CITY OF ALBUQUERQUE

RE: **Lot 1 Block 5 Unit 18 SAD 228
6601 Papagayo NW
Volcano Cliffs Subdivision
Grading and Drainage Plan
Engineers Stamp Date 10/7/2025 (D10D003K1, HYDR-2025-00375)**

Grading Plan

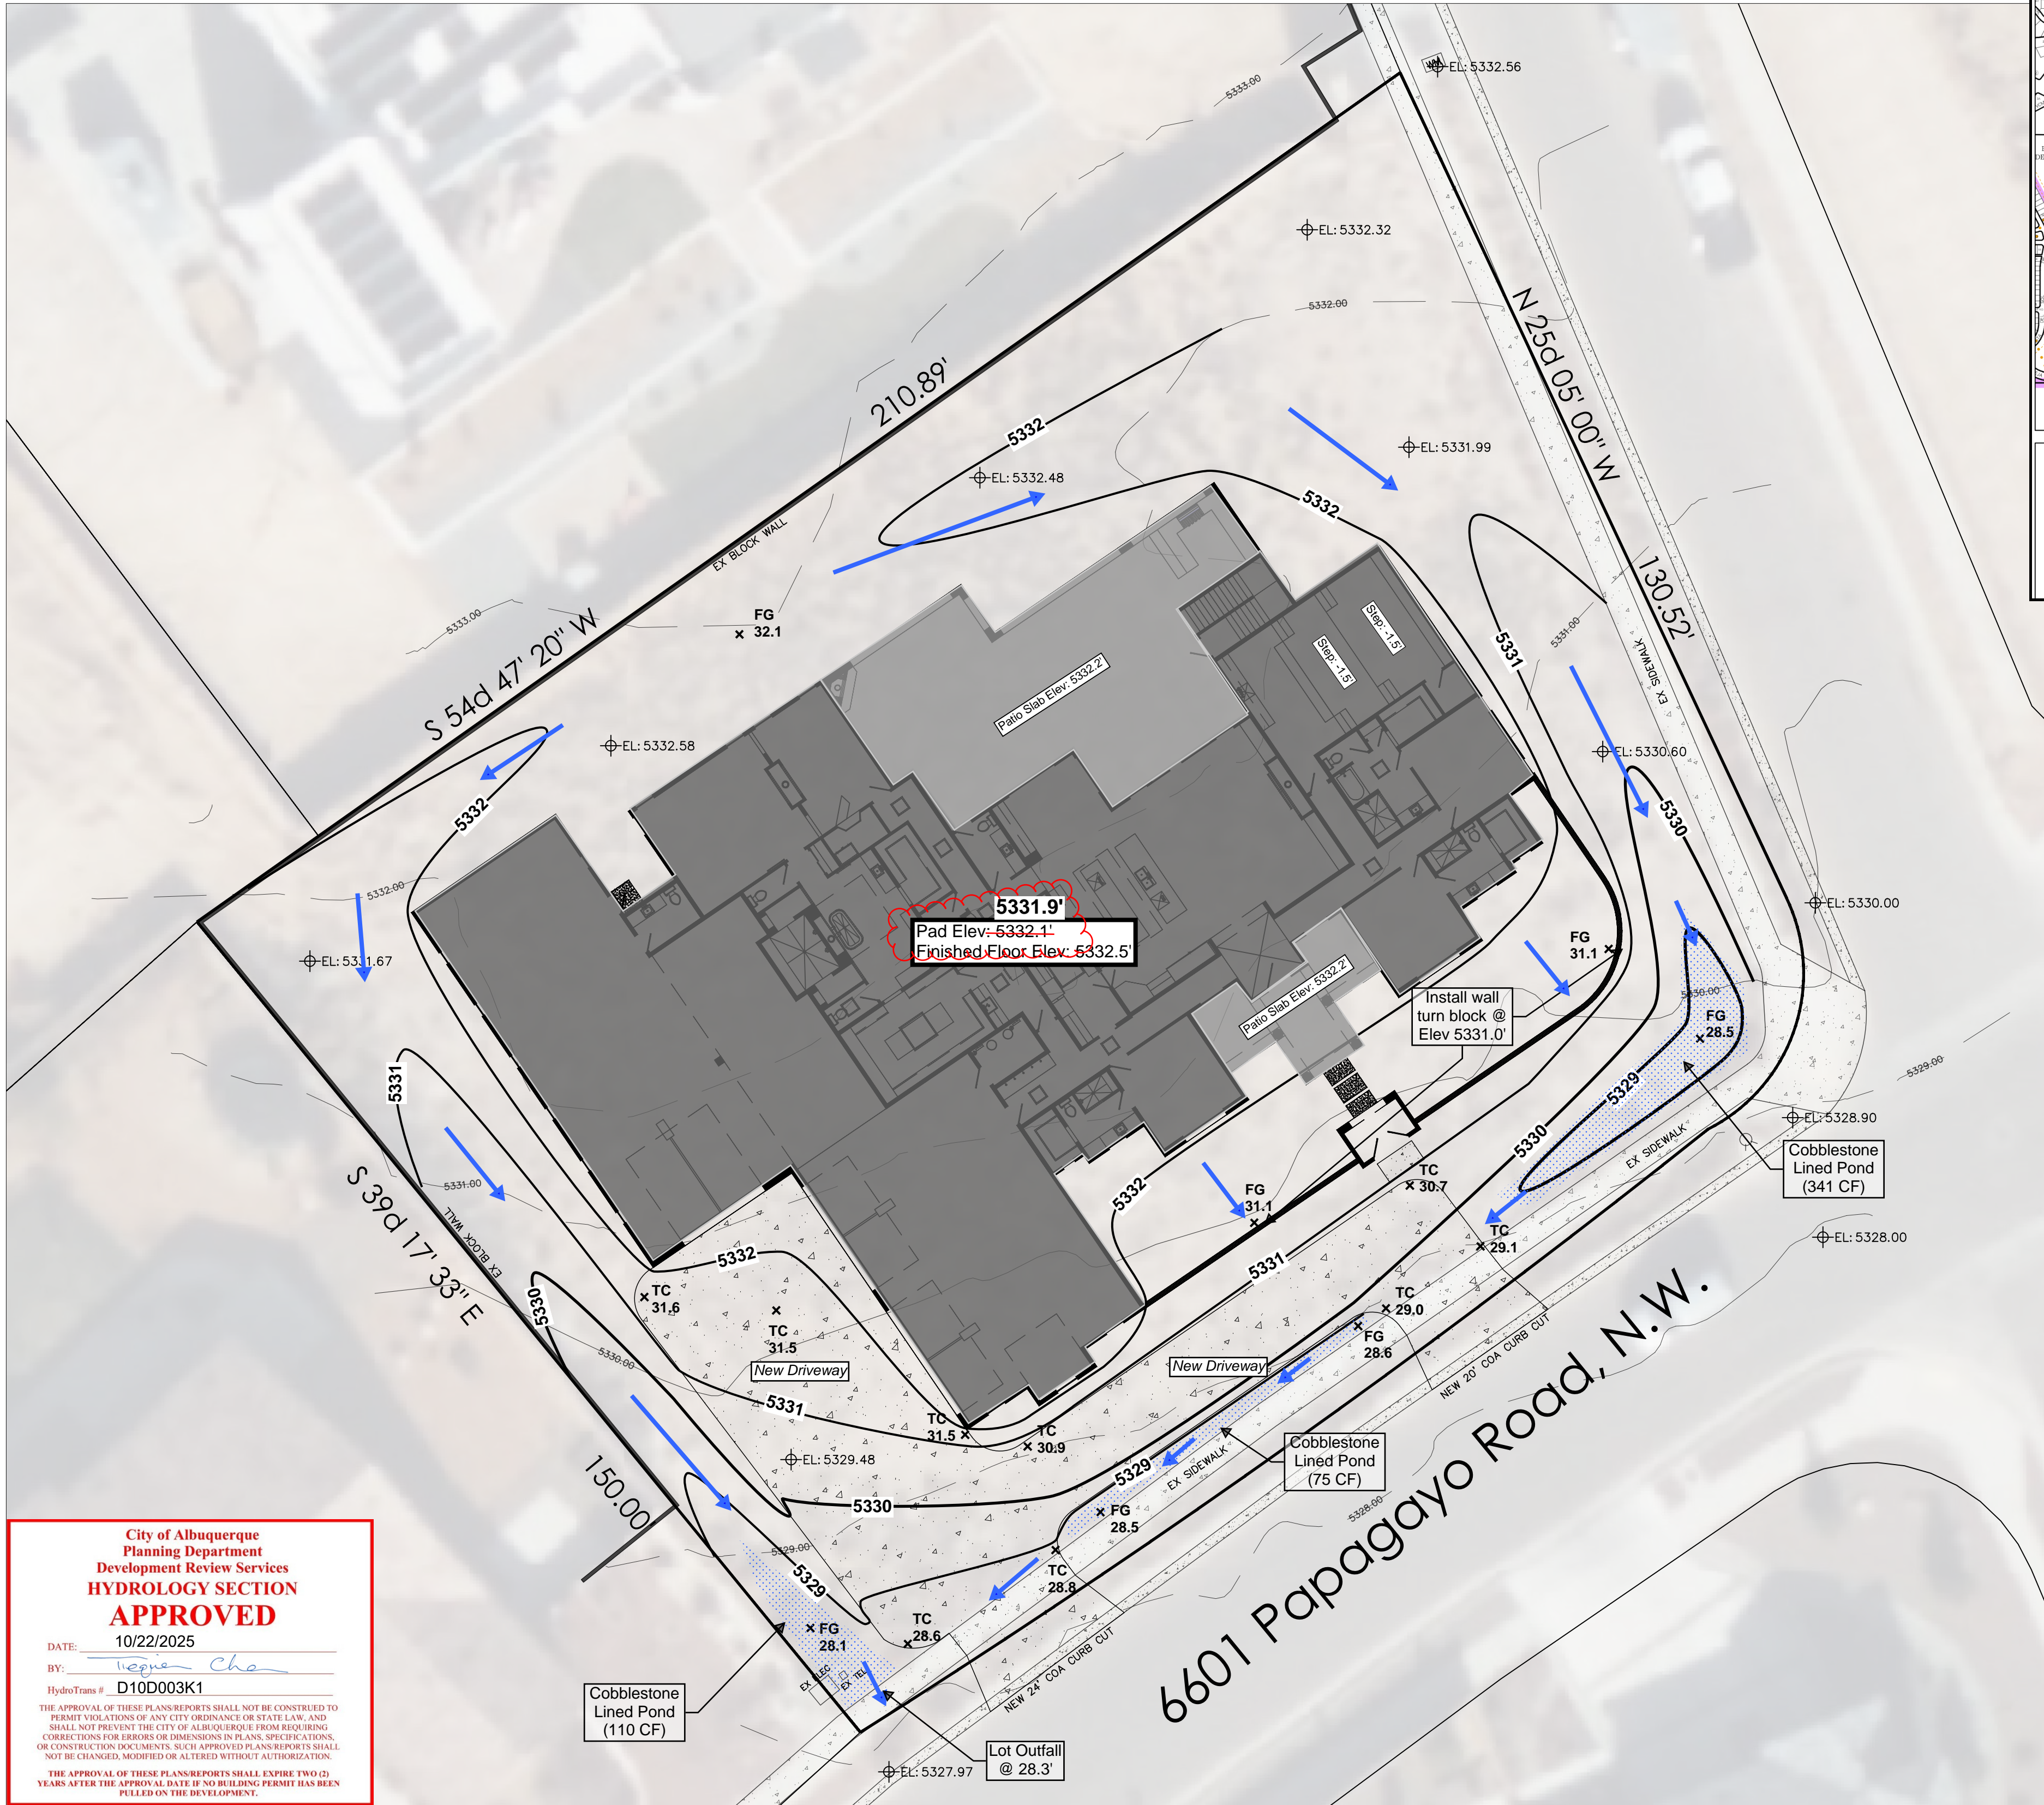
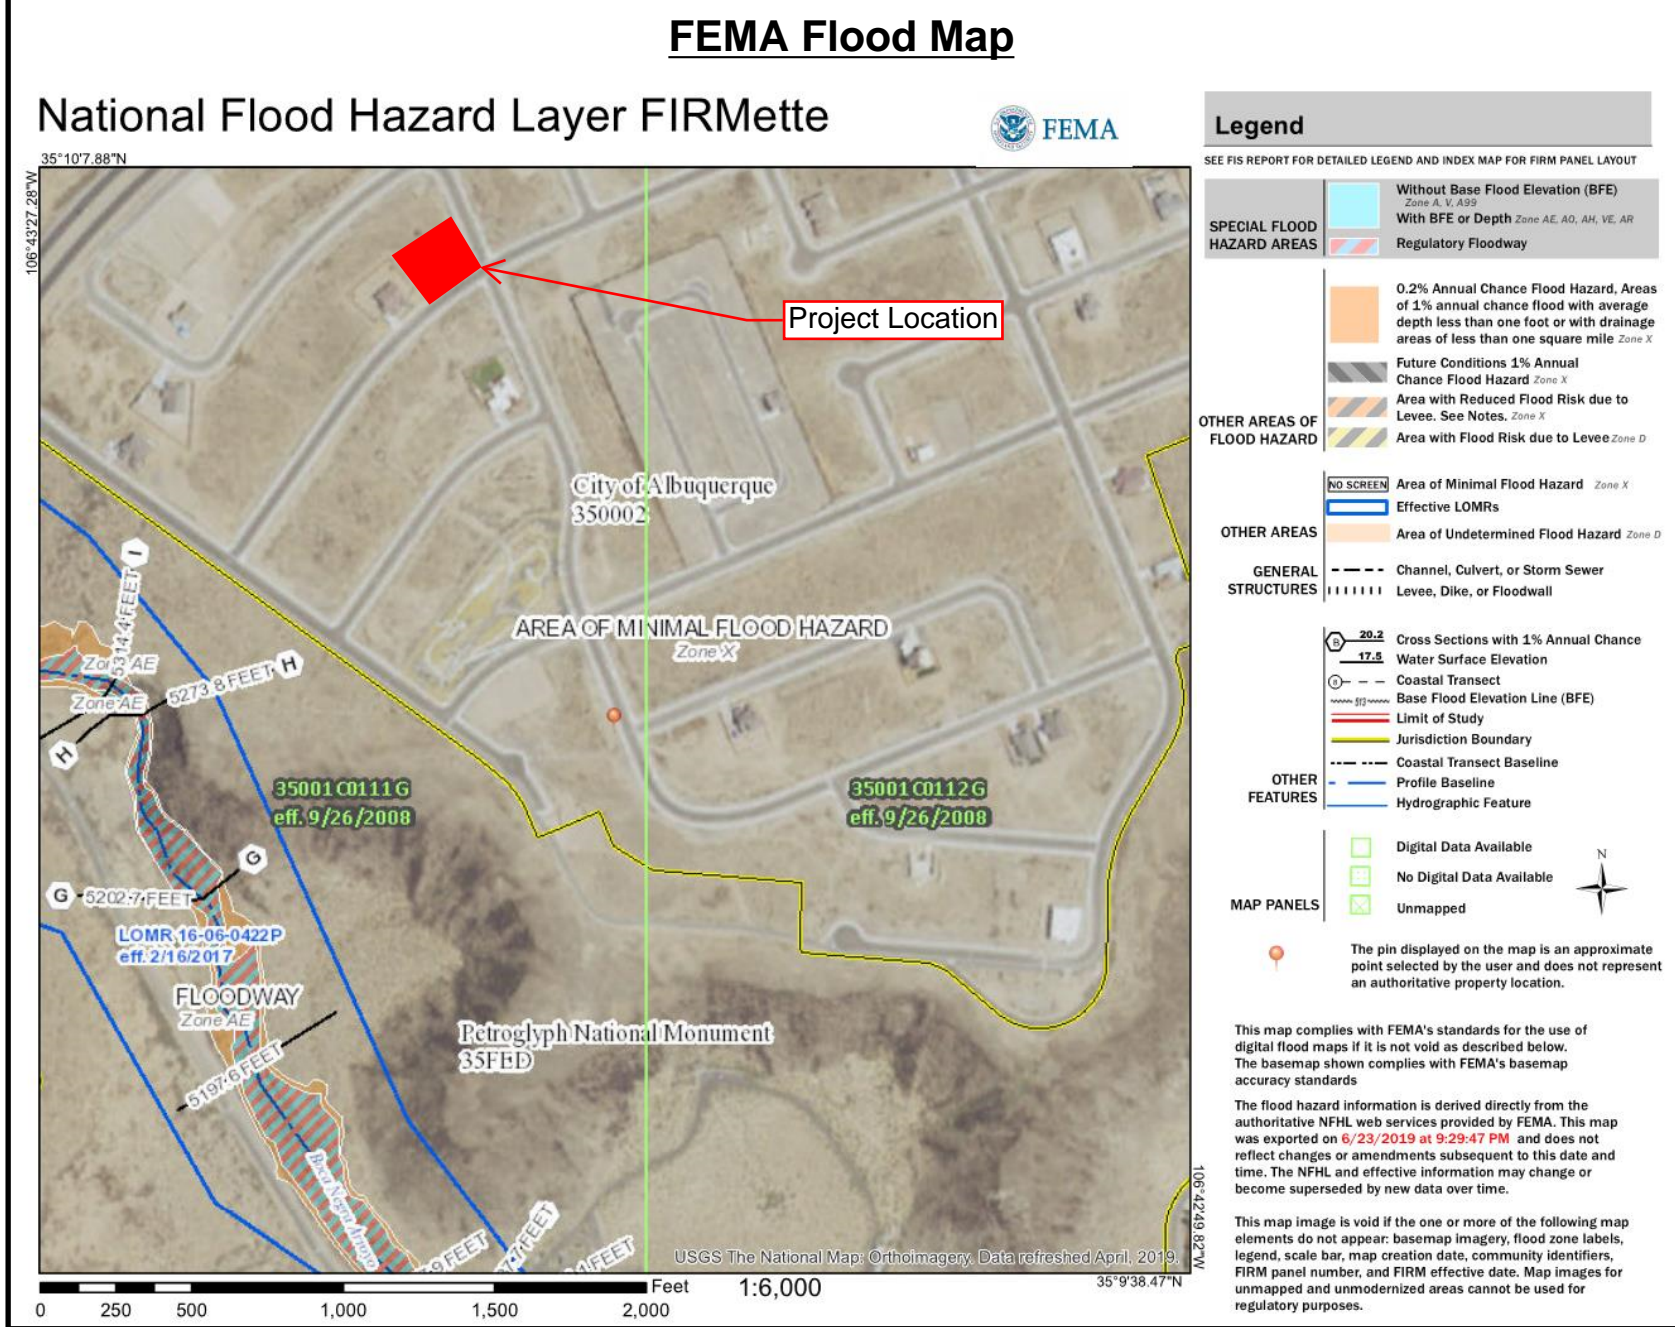
Advise the owner contractor not to use dirt as a ramp to climb the curb, use lumber or crusher fines for this purpose. Place this note on the plan.

Reiterate to the Owner/Contractor that a separate permit for a garden/retaining wall must be obtained with the approved G&D plan and Pad Certification. **Also, if a swimming pool is to be placed after this approval a new grading and drainage plan will need to be resubmitted showing the changes for the land treatments.**

Prior to Certificate of Occupancy release, Engineer Certification per the DPM checklist is required.
